**NUMBER:** 08-175-22 REV. A

Water Intrusion and Corrosion in Connector XY101A

2022 (RU) Chrysler Pacifica

**Fig. 1**  
**Ground Location**

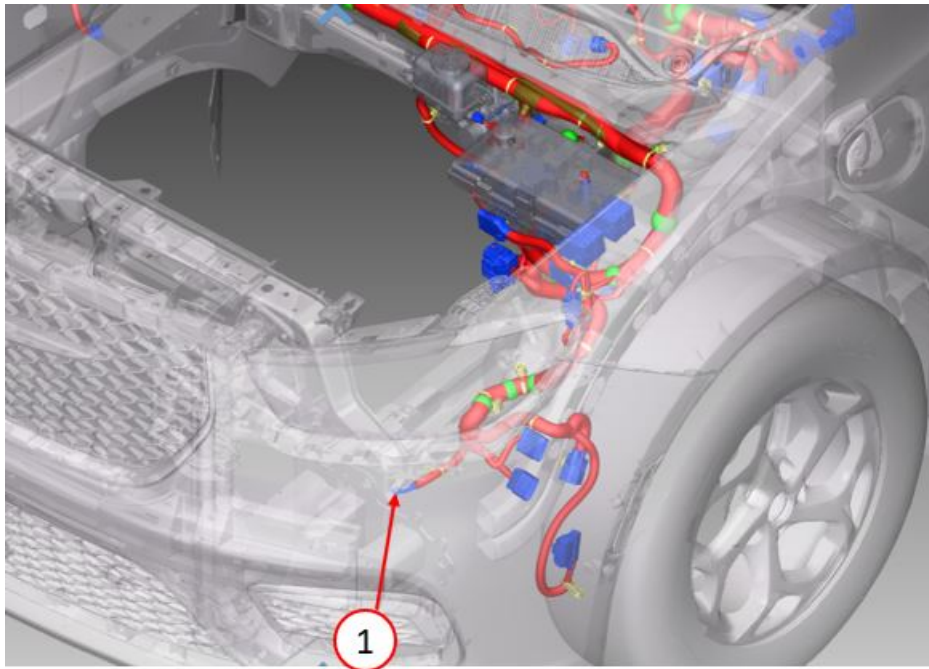
1. Remove air intake system. Refer to the detailed service procedures available in DealerCONNECT> Service Library under: 09 - Engine, 3.6L / Air Intake System / Body, Air Cleaner / Removal.
2. Is the vehicle a PHEV?
  - YES>>> Proceed to [Step 4](#).
  - NO>>> Proceed to [Step 3](#).
3. Remove the battery and battery tray. Refer to the detailed service procedures available in DealerCONNECT> Service Library under: 08 - Electrical / 8F - Engine Systems / Battery System / Tray, Battery / Removal.
4. Locate G917A and disconnect the ground from the chassis and the gray harness retainer ([Fig. 1](#)).

**Fig. 2**  
**Zip Ties Installed**

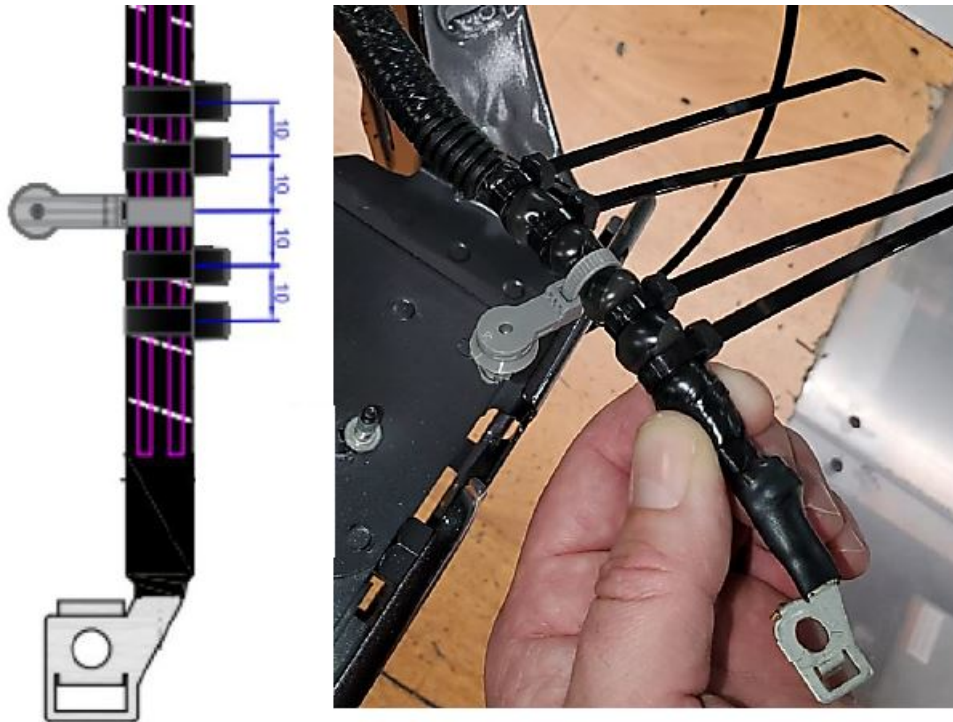
5. Place four zip ties (10mm (3/8 inch) apart two on each side of the existing grey offset retainer) around G917A to place firm clamp load on existing butyl (Fig. 2) .

6. Cut the loose end of the zip ties off. Wrap the zip ties in vinyl tape.
7. Is the vehicle a PHEV?
  - YES>>> Proceed to [Step 9](#).
  - NO>>> Proceed to [Step 8](#).
8. Install the battery and battery tray. Refer to the detailed service procedures available in DealerCONNECT> Service Library under: 08 - Electrical / 8F - Engine Systems / Battery System / Tray, Battery / Installation.
9. Install the air intake system. Refer to the detailed service procedures available in DealerCONNECT> Service Library under: 09 - Engine, 3.6L / Air Intake System / Body, Air Cleaner / Installation.
10. Clear all DTCs that may have been set in any module due to this repair procedure.
11. Turn the ignition 'Off' than 'On' again. Check if any DTC reset. Refer to all applicable published service bulletins and Star Online Publications for additional repair procedures and further diagnostic.
